**PUD-125
2350 Santa Rita Road, Carpenter's Training Facility
July 26, 2017**

Re: Planned Unit Development PUD-125 (2350 Santa Rita Road)

Application for Planned Unit Development development plan to demolish an existing 67,000-square-foot building to construct a new 87,000-square-foot two-story Carpenter's Training Center and pad for a future 17,000-square-foot office building with associated site improvements located at 2350 Santa Rita Road.

PUD-125, 2350 Santa Rita Road, Carpenter's Training Center

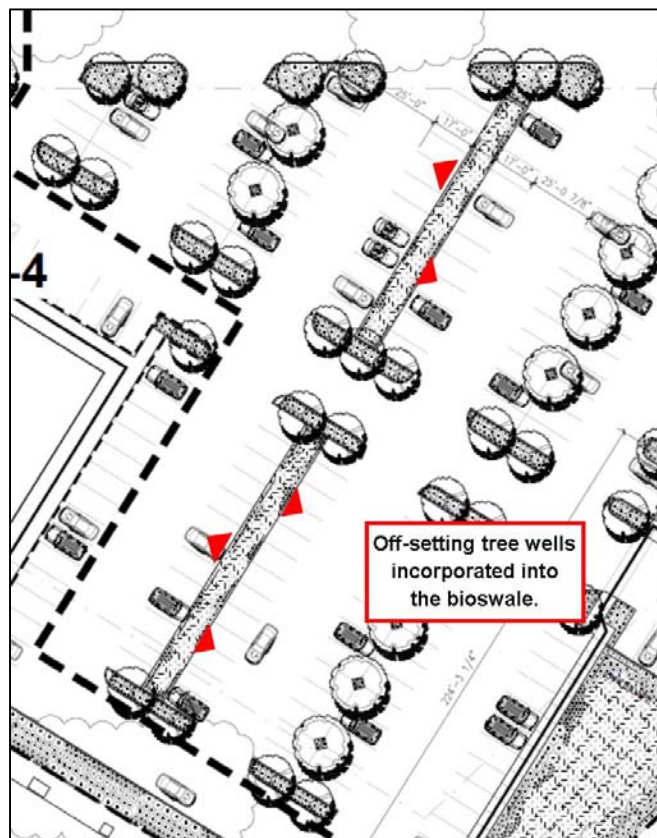
6. Please revise irrigation note #8 to reflect Pleasanton Municipal Code requirements and not South County Regional Water Reuses Authority.
7. Please add an additional narrow landscape planter along the south side of the proposed Training Facility trash enclosure. In addition please extend the landscaping along the north and east side of the enclosure all the way up to the enclosure wall.
8. Please add off-setting tree wells adjacent to the central parking lot bioswale similar to the diagram below.
